**New Alternator Pulley and Belt**

Binder - Service Technical Bulletins  
This Bulletin replaces bulletin,  
Group 1, # 7/97, dated 7-10-97.

Vehicle Type: **911 Carrera as of M.Y. 1995 and 911 Turbo as of M.Y. 1996**

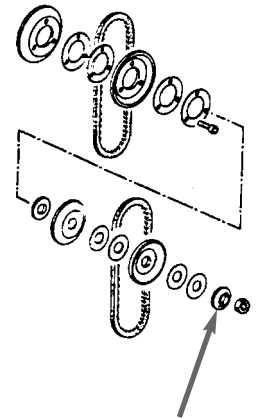
Concern: In case of alternator belt failure or belt noises in conjunction with pulley, part number, 993 106 268 00 (s/s to 993 106 268 01), the alternator belt and pulley must be replaced.

When installing the new version pulley halves on the 911 Carrera and Turbo, the distance spacer, (see arrow, illustration) is machined as part of the new version pulley and is no longer required. Because of this, it is no longer possible to store adjustment shims behind the distance spacer on the outside of the alternator pulley. Shims removed during the tensioning procedure should be stored in the vehicle tool kit. The tensioning procedure can be found in Repair Group 13, page 13 - 32.

Information: **911 Turbo:**  
When repairs are necessary, install only the new version belt and pulley halves.

Description	Part Number
New belt (1 ea.)	999 192 372 50 (757 mm long)
Pulley halves (2 ea.)	993 106 268 01 (Yellow, chromated color) *
Shim (0.5 mm)	964 106 268 31 (as required)
Shim (0.7 mm)	964 106 268 32 (as required)

The new version pulleys can also be installed on the 911 Carrera. However, the previous version belt must be used.
